## JACKS AND PLUGS IDENTIFICATION AND SERVICE

1.001 This addendum supplements Section 461-630-100, Issue 9. Place this pink sheet ahead of page 1 of the section.

Fig. 13.1—267A Adapter (Plugged Into 625B Connecting Block)

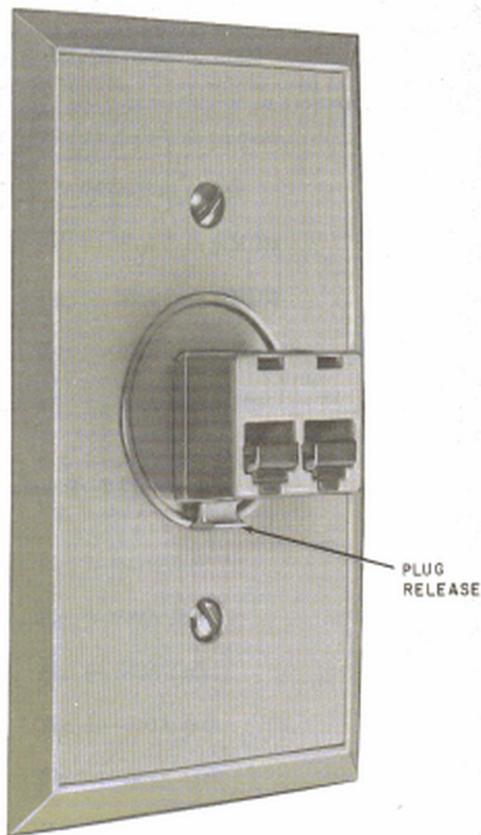
2.002 Add Fig. 13.1 and 13.2.

- Fig. 12, 13, and 13.1 show adapters used with plug-ended mounting cords.

- (c) The 267A adapter (Fig. 13.1) consists of two modular line cord type jacks connected

to a single modular line cord type plug. It can be mounted piggy-back on a 224A or 225A adapter or plugged directly into an existing modular jack.
